CWSP SYSTEM HARDENING FIELD SCOPING DOCUMENT

PM: [REDACTED]	Project Name: SH - BUCKS CREEK 1101 CB	
Notification: 120047659	Region: Northern	City: Rock Creek
Project Manager: [REDACTED]	Division: North Valley	County: Plumas

- A) **Project Area** – Google Earth Image with Circuit and HFTD Tier 2 &3 Overlay

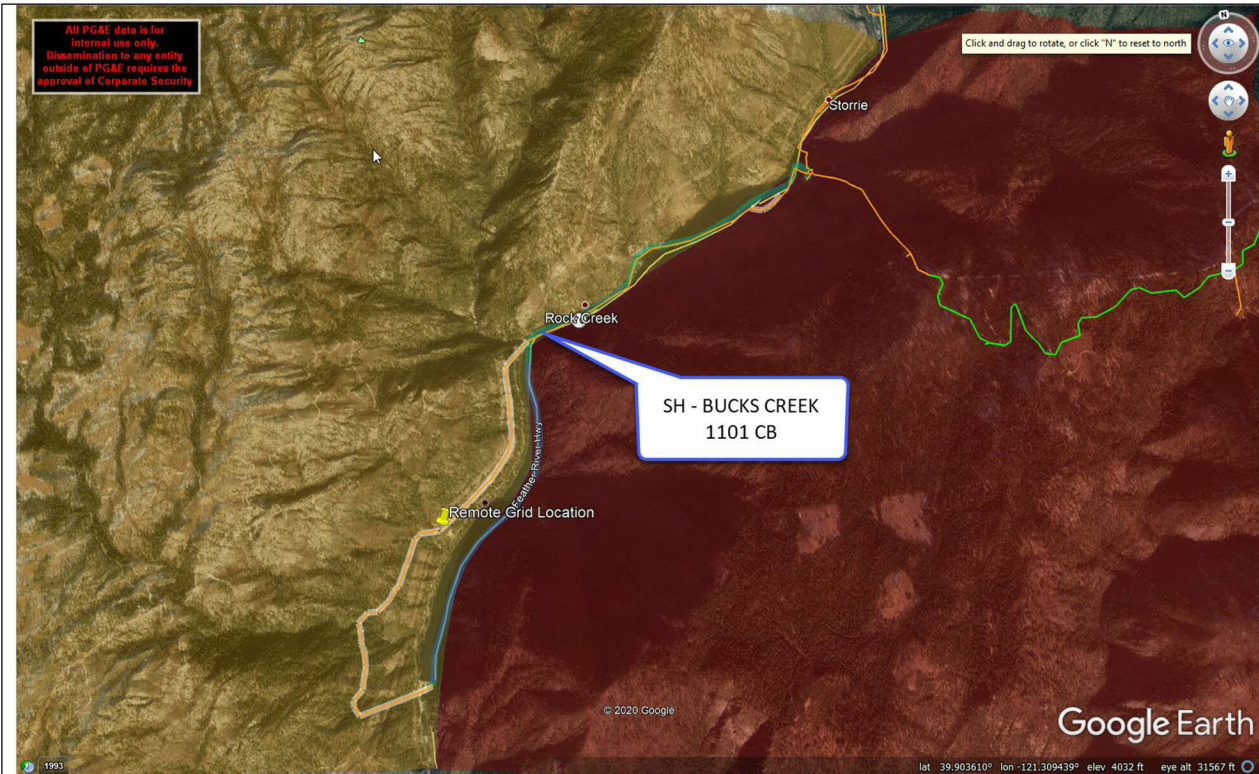
- This project crosses Highway 70 near the Bucks Creek Powerhouse and then parallels the highway for a roughly 2-mile stretch, and then runs along Storrie Rd. paralleling the Feather River on the canyon opposite side of Highway 70. Highway 70 is a main thoroughfare for ingress/egress for emergency responders and to the few residents who live in that direct area; it is also a major route for commerce both by vehicle and railroad.
- If Highway 70 was closed in this area it would make ingress and egress difficult if not impossible for responders and citizens; and, economically be a substantial hit to commerce. There are no alternative routes within the Feather River Canyon.

B) Fire History – WIFire Map at <https://firemap.sdsc.edu/> to produce the fire history image.

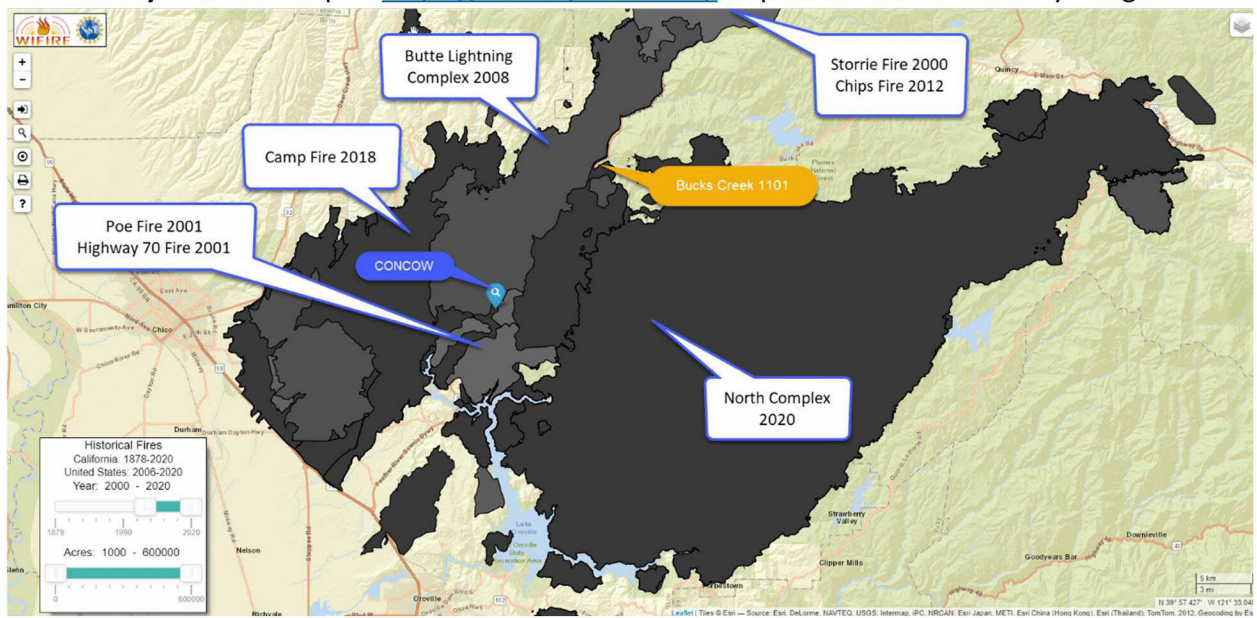
- This area has significant fire history directly impacting the project area. A 20 year look back at area fire history includes, the 56,000 acre Storrie fire (2000), 8,000 acre Poe fire (2001), 1700 acre Highway 70 fire (2001), 50,000 acre Butte Lightning Complex (2008), Canyon Complex (2008), 30,000 acre Chips Fire (2012), 154,000 acre Camp fire (2018) and the 320,000 acre North Complex 2020 all burned within the Feather River Canyon.

- Not all the fires were directly in the project footprint area; however, they show that this area is prone to significant, large fire history due in large part to steep, rugged, inaccessible terrain and periods of strong wind.
